Fontenelle Natural Gas Infill Drilling Projects, Sweetwater and Lincoln Counties, Wyoming, Final Environmental Impact Statement

**Fontenelle Natural Gas
Infill Drilling Projects**

**Final
Environmental Impact Statement**

Figure 2-6

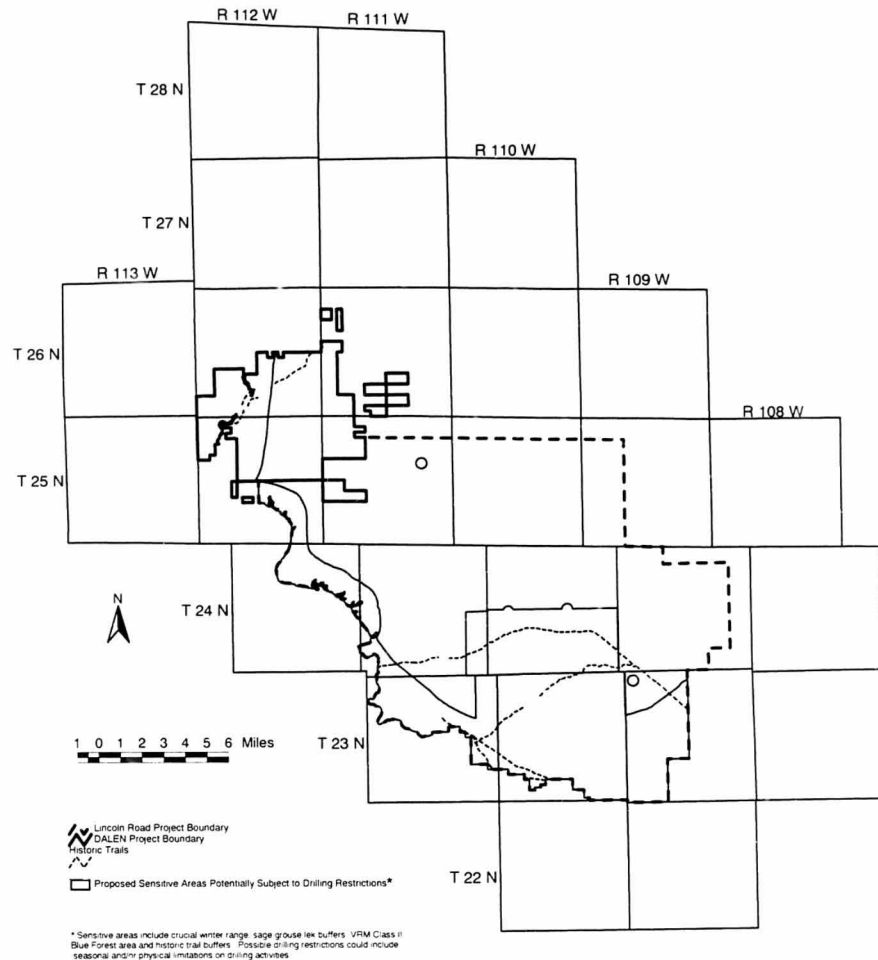
Therefore, an alternative that includes directional drilling as a blanket requirement is not examined further in this document. However, directional drilling would still be a required consideration on a case-by-case basis in the sensitive surface resource value areas shown in Figure 2-6.

4-11	In the Aquatic Resources section., delete: "This has forced ... accumulated sediment."
4-19	In Section 4.6.1, delete: "While the entire area may be used for hunting ... significance." Substitute: "Hunting and dispersed recreation activities can occur in both project areas; however, affected lands do not provide recreation opportunities of regional or national significance. The project areas are utilized by some antelope outfitters but no other tourism-related businesses; except for rock collecting in the Blue Forest area, neither are they typically considered a recreation destination by tourist, back country users or hunters."
4-22	In Section 4.6.4.1, to end of paragraph add, "The BLUE Forest petrified wood collecting area would be an avoidance area for surface disturbing activities, including seismograph lines, access roads, well pads, and buried pipelines. This area is included within the sensitive area shown on Figure 2-6 and would be subject to construction and drilling restrictions."

Figure 3-13
Antelope Seasonal Ranges Within the Cumulative Impact Study Area

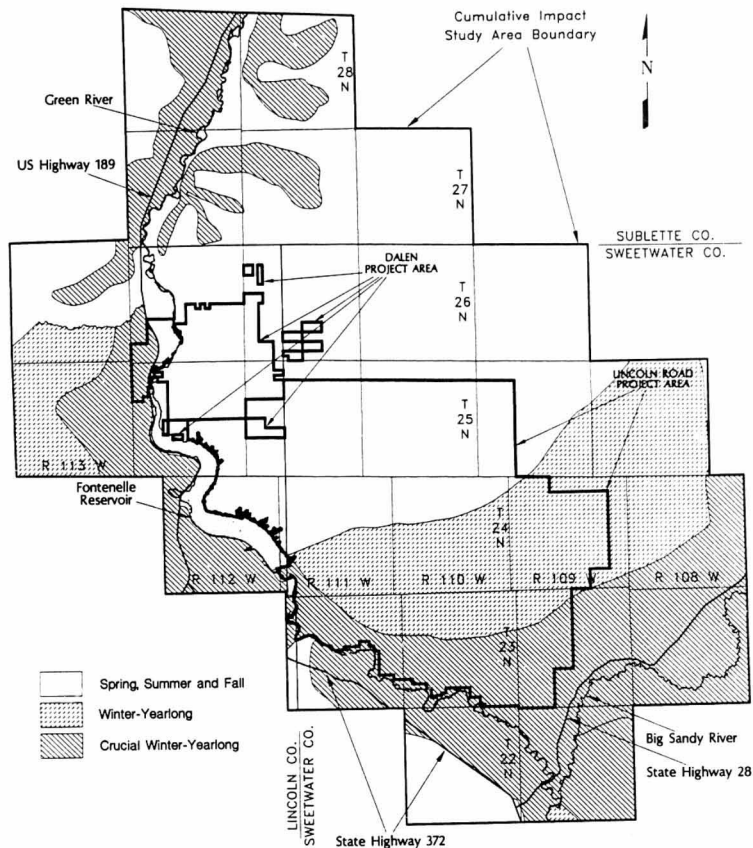
Page	Errata
3-45	Table 3-24, heading for 6th column should read "Average 5-year AUM Use."
3-57	Figure 3-13 in the DEIS was incorrect. A correct Figure was used in the wildlife modeling technical report which was discussed in the DEIS and issued concurrently as a supplemental technical report. The corrected Figure 3-13 has been reprinted at the end of this section.
Chapter Four	
4-9	In Section 4.2.3, second paragraph, insert the following statement after "...wetland/riparian, and threatened, endangered, and species of concern": "This is due to the fact that activities in the Fontenelle area are geographically isolated from these resources in the Jonah and Stagecoach fields. For example, noise from a drilling operation in the Fontenelle area is not additive with noise from a drilling operation in the Jonah Field."
4-9	In the Land Use section delete: "designated land uses". Replace with: "Nor would there be any change in the principal or major land uses, which include oil and gas production, livestock grazing, fish and wildlife habitat, and recreation."

Comment 4-2. The Wyoming Game & Fish Department recently changed the boundaries of pronghorn ranges. These new range boundaries were reflected in the analysis conducted for the DEIS and the wildlife models technical report. A correct version of Figure 3-13 was included in the technical report. Figure 3-13 in the DEIS included a drafting error which has been corrected in the FEIS (see Section 2, Errata).
